Subject: Dresden Station Units 2 and 3
Quad Cities Station Units 1 and 2
NUREG 0737 Items II.F.1.4, 5 and 6
Containment Pressure, Water Level and
Hydrogen Monitoring
NRC Docket Nos. 50-237/249 and 50-254/265

ATTACHMENT
COMMONWEALTH EDISON COMPANY

Response to NRC Request
For Additional Information concerning
NUREG 0737 Items:

- II.F.1.4 Containment Pressure Monitor
- II.F.1.5 Containment Water Level Monitor
- II.F.1.6 Containment Hydrogen Monitor

FIG 1

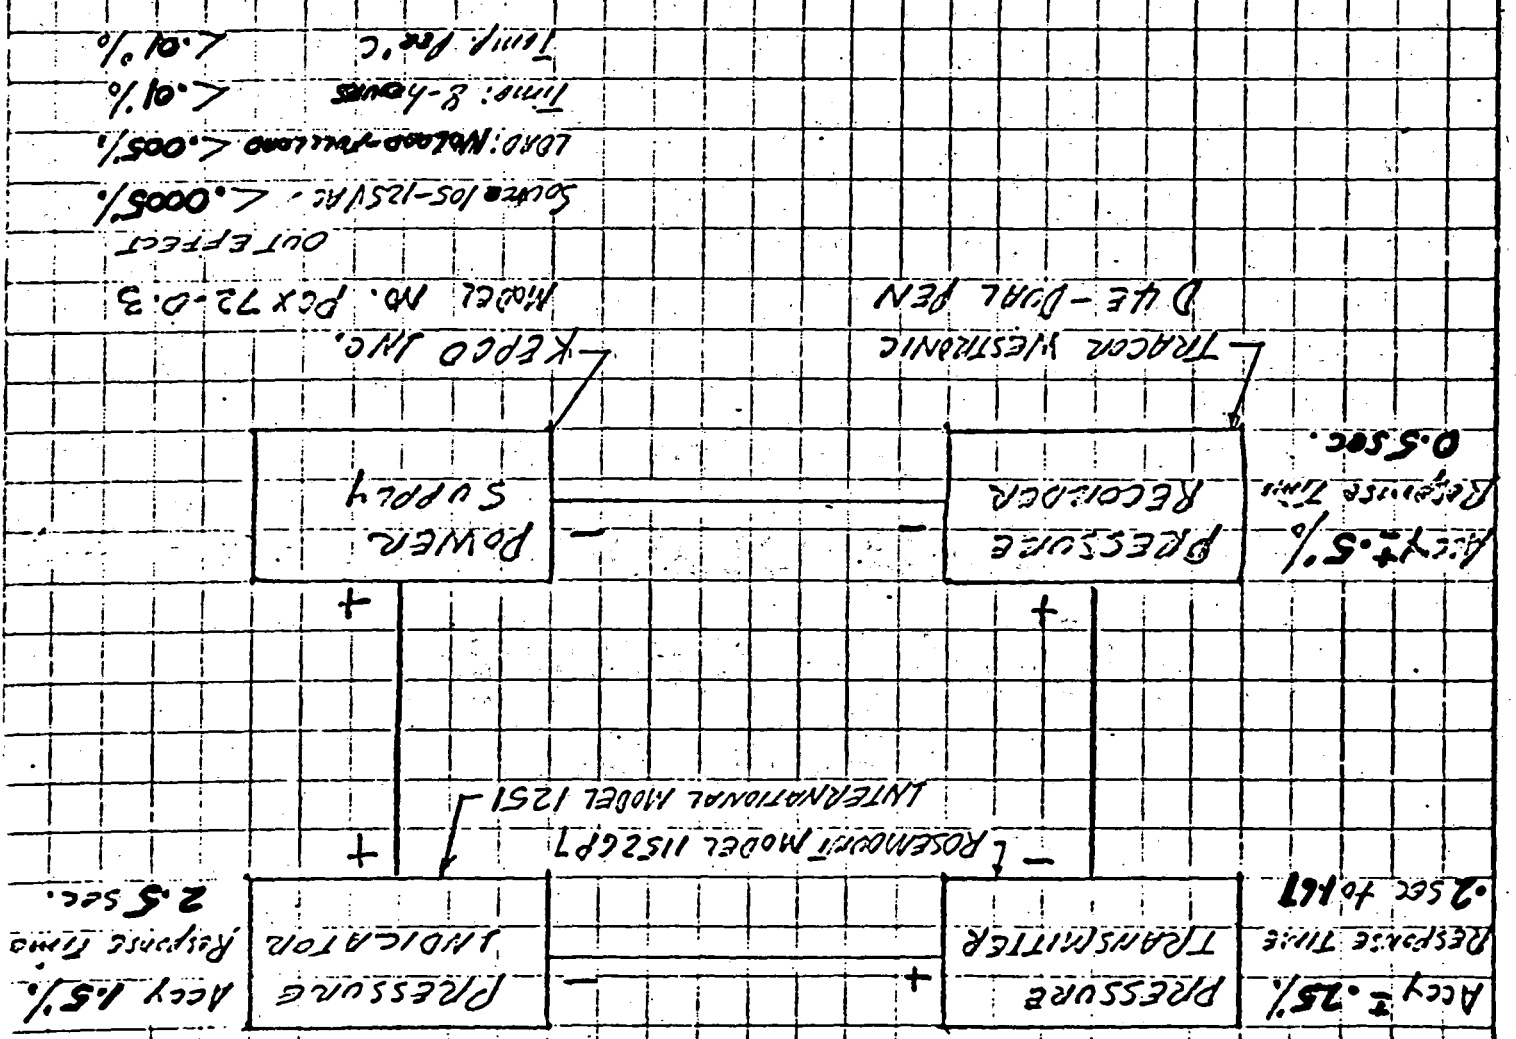
(2a) See the attached block diagram Fig. 1.

(2b) The following is a list of parameters which affect the accuracy of each module:

- a. Stability \pm 0.25%
- b. Total temperature effect \pm 1.1%
- c. Seismic performance \pm 0.25%
- d. Radiation performance \pm 0.70%
- e. Power supply effect \pm 0.005%
- f. Calibration error \pm 0.5%

(2c) By combining the uncertainties within each module and then combining the uncertainties of each module within a loop by the square root of the sum of the squares method, the following overall loop uncertainties were derived:

- a. Transmitter to indicator: 7.06% error
- b. Transmitter to recorder: 5.51% error

(2d) The following is the time response for each component:

- a. Instrument tubing 0.1 sec. (estimate)
- b. Transmitter 0.2 sec. to 1.67 sec. adjustable (time constant)
- c. Indicator 2.5 sec. (maximum response time)
- d. Recorder 0.5 sec. full scale (step response)

(2e) Under the assumption that the transmitter time constant is set at its minimum value of 0.2 seconds, then the system response time to the recorder should be less than 1 second. Summing the response times of the components gives a system response time of less than 3 seconds.
